NEDO-32983-A, Revision 2

General Electric Methodology for Reactor Pressure Vessel Fast Neutron Flux Evaluations

SUBJECT: FINAL SAFETY EVALUATION REGARDING REMOVAL OF METHODOLOGY LIMITATIONS FOR NEDC-32983P-A, "GENERAL ELECTRIC METHODOLOGY FOR REACTOR PRESSURE VESSEL FAST NEUTRON FLUX EVALUATION" (TAC NO. MC3788)

Figure 2-4. Sample Relative Neutron Flux (E>1 MeV) vs. Axial Elevation at Shroud ID

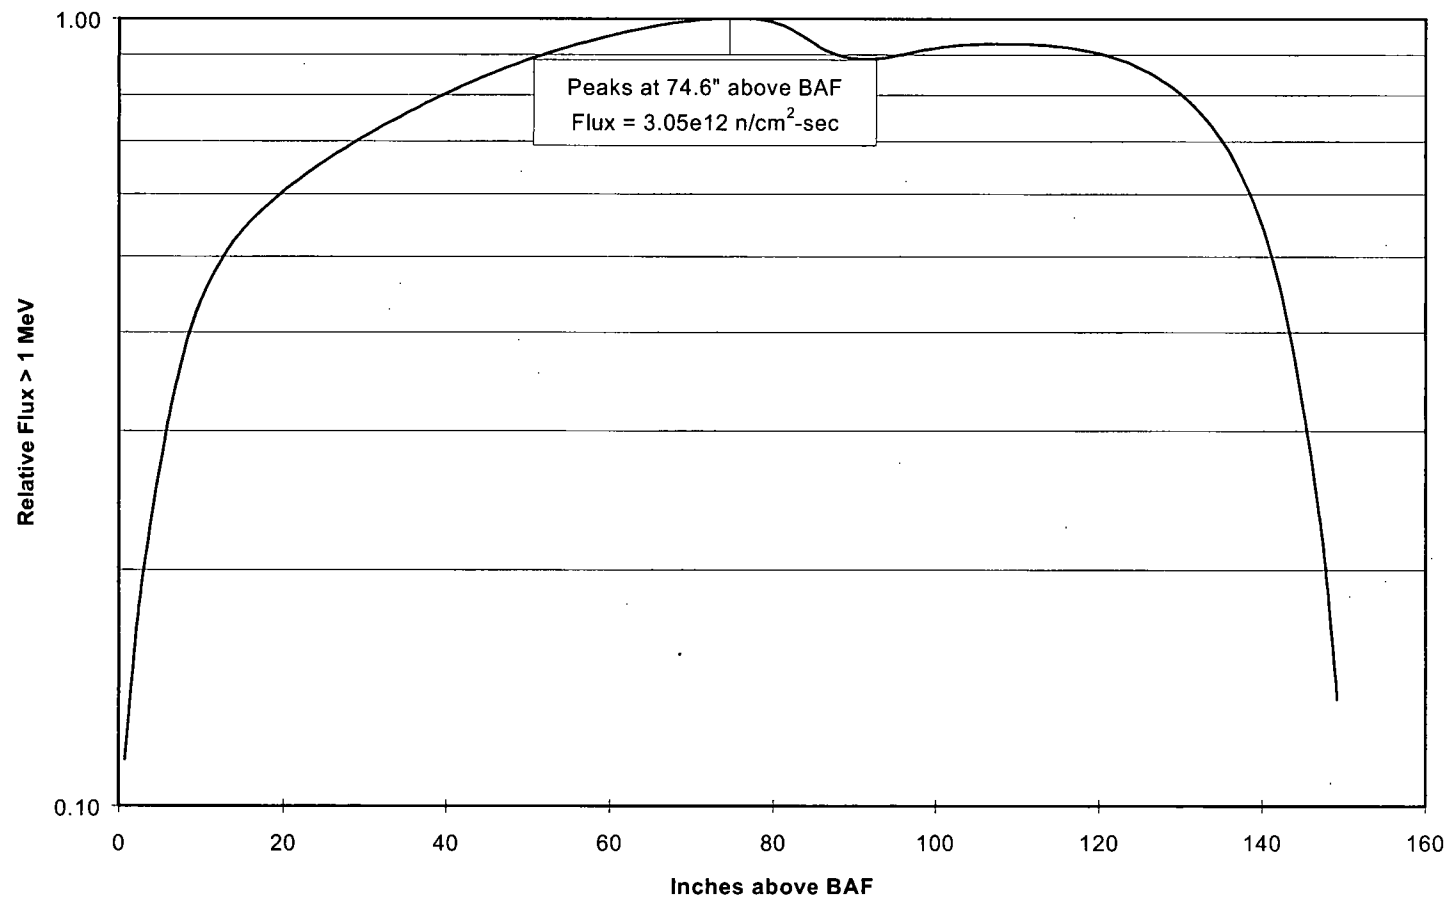
Provide an explanation for the radially-dependent bias in the benchmark experiment C/M data of Figures 5-4, 5-5 and R9-1. Does this indicate that calculations based on the proposed methodology will over-predict the fluence at locations inside the vessel inner-wall? Provide justification for not including this bias in the calculation methodology. In view of the data in Figure 9-1:
